802.3dj D3.0

Comment Resolution

Logic Topics

Figure 171–3a—Example 1.6TBASE-R PMA layering with 1.6TXS

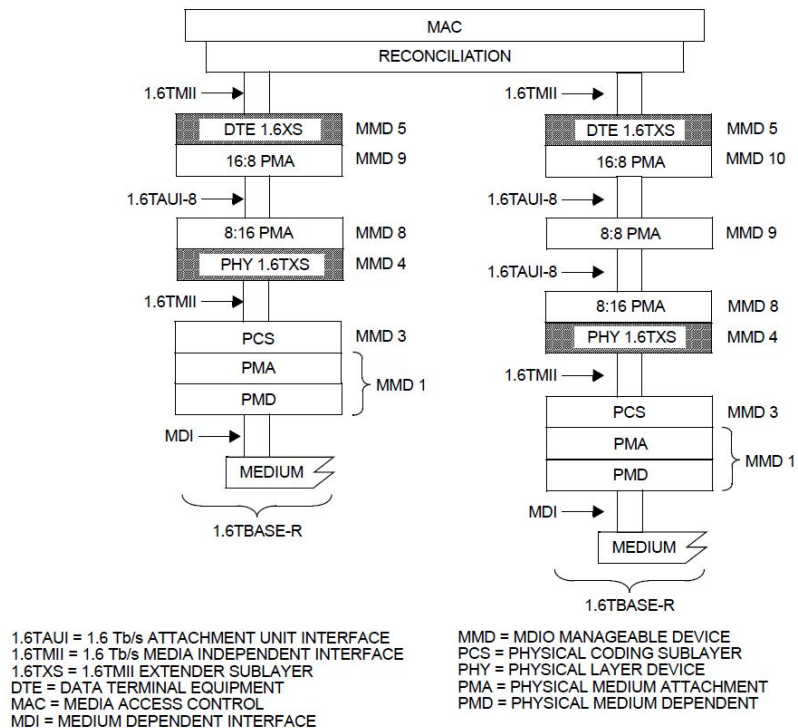
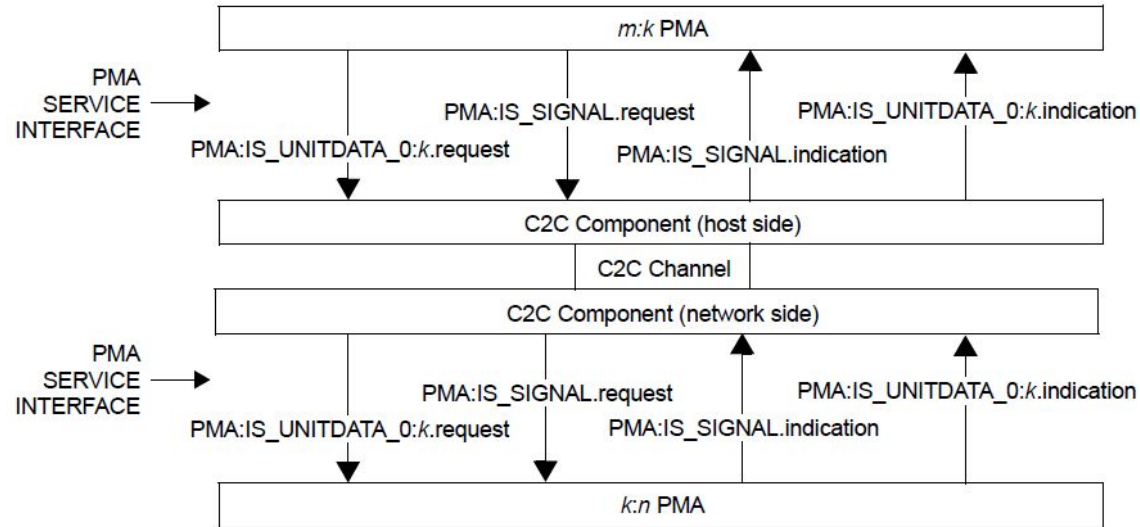
CI **45** SC **45.2.1.272** P **123** L **25** # **365**

The title of this section is not entirely true as it a replica of all the registers which is more than jus the ILT training registers.

Change the title of 45.2.1.272 to be "Registers for the upper AUI component"

PROPOSED ACCEPT IN PRINCIPLE.

Change the title of 45.2.1.272 to be "Registers for the upper (host side) AUI component".

"Control and status registers are required for both the upper (host side) and lower (network side) AUI components (see Figure 176C-3 and Figure 176D-3)."

"Register descriptions referring to the "PMD" should be interpreted as also referring to the AUI."
